**Planning Commission Agenda**  
**February 19, 2025**

**RE: Site Plan Review – 58 Park**

**Background:** Hillsdale College is proposing a new building located at 58 Park. The proposed building is to be used for incoming mail and sorting as well as miscellaneous office space. The project has been reviewed by the city department heads, the report is included. Planning Commission members shall visit the site for field review. Zoning Administrator is requesting approval of the site plan.

Below is a list of the items cited during the review the plans of the proposed multi-use building to be located at 58 Park Street. The City Department Heads reviewed the plans and responded to the Zoning Administrator by email: Alan Beeker (Planning & Zoning), Jeff Gier (Board of Public Utilities), Jake Hammel (Board of Public Utilities), Jason Blake (Department of Public Services), Dan Poole (Fire Dept.)

**HILLSDALE COLLEGE**  
 PARK STREET MULTI-USE BUILDING  
 SITE LAYOUT PLAN  
 DESIGN DEVELOPMENT

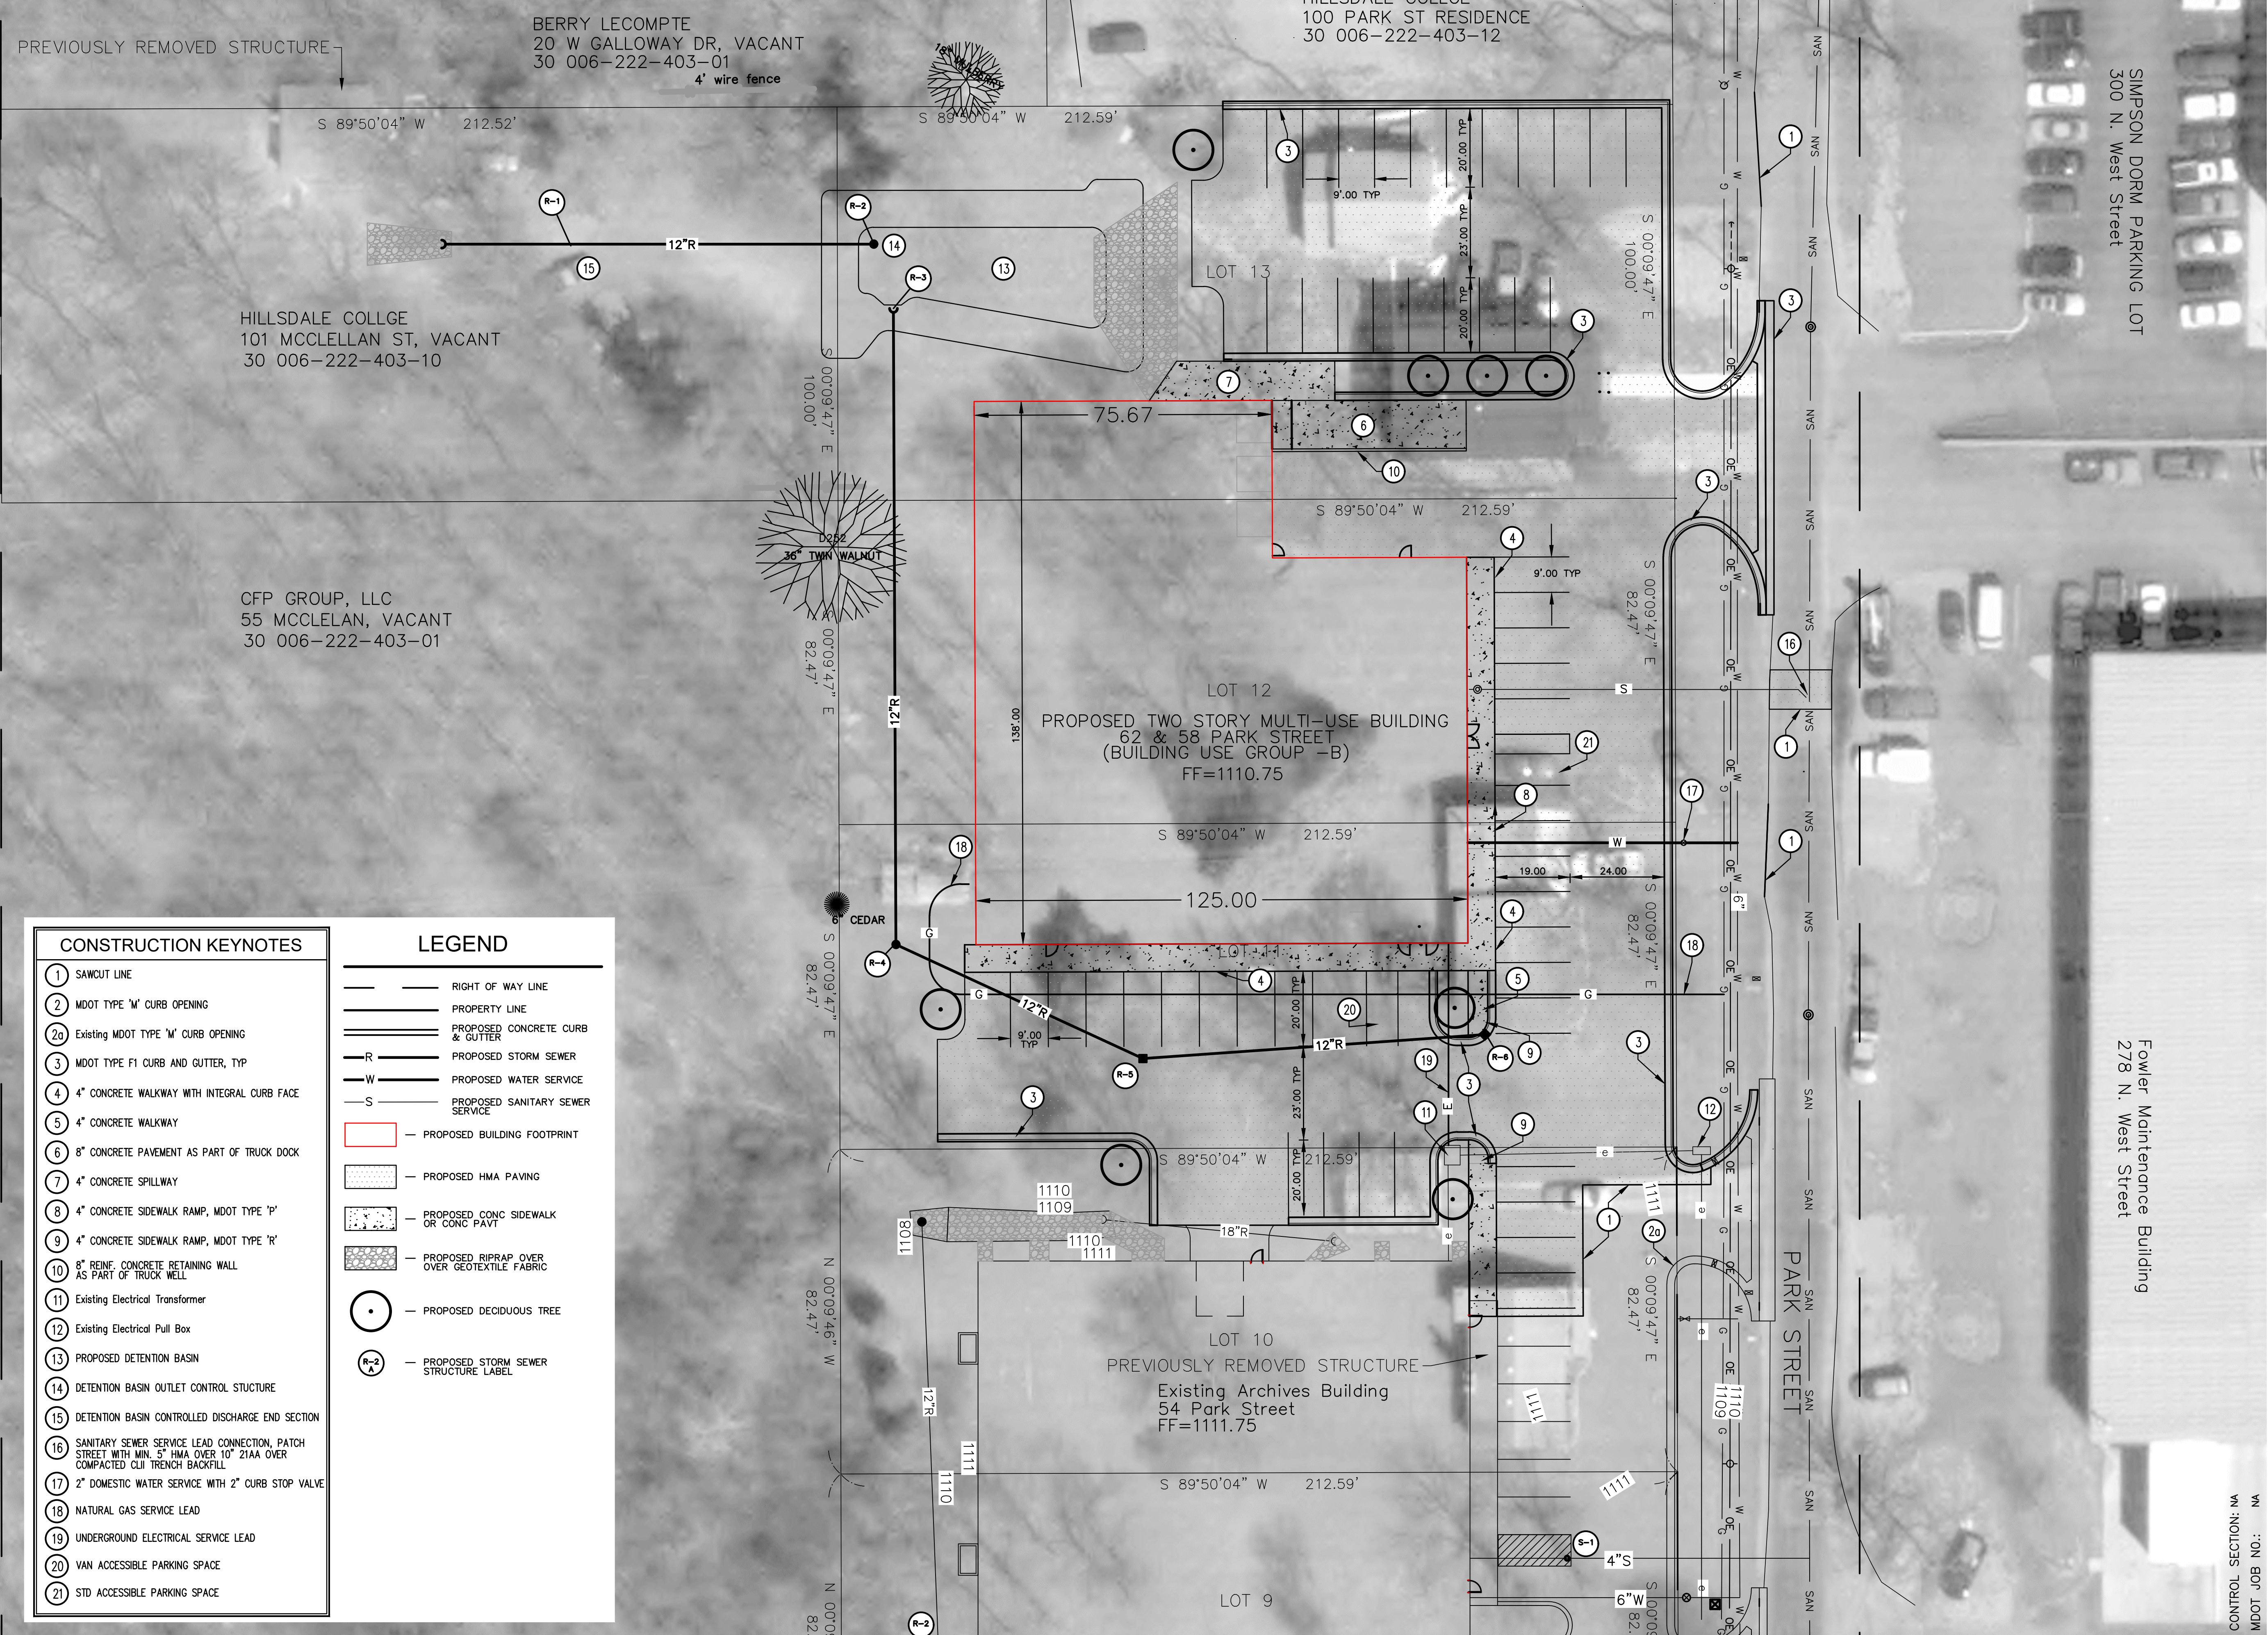
- Asked about location of FDC (building not suppressed)
